Docket Item # 2 BAR CASE # 2011-0318

BAR Meeting November 30, 2011

ISSUES: Shed

LOCATION: 404 North Henry Street

Figure 1. Location of proposed shed. The shed, as installed, sits closer to the front façade of 404 N. Henry Street than shown here.

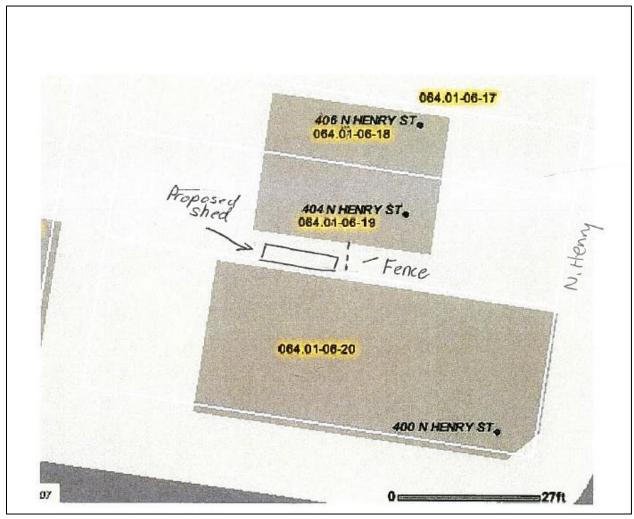
The lot will continue to comply with the required open space and floor area ratio requirements with the proposed shed. Because the lot is less than 25 feet in width, there are no required side yard setbacks but the shed must be located behind the front building wall.

this townhouse. Furthermore, although the proposed shed will be visible from North Henry Street, Staff notes that it is adjacent to a blank cinder block wall and behind a six foot tall fence and significant landscaping.

Figure 2. Proposed shed design.

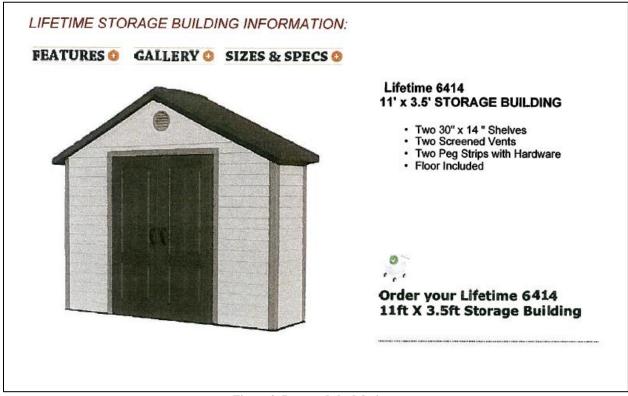
Unfortunately, the proposed shed could not be administratively approved because of its height (9 feet 4 inches) and its proposed location in a non-required side yard. This shed replaces an existing shed in this general location. The proposed shed is simple in style and appropriate for

Staff supports the proposed application for a shed and fence as submitted.
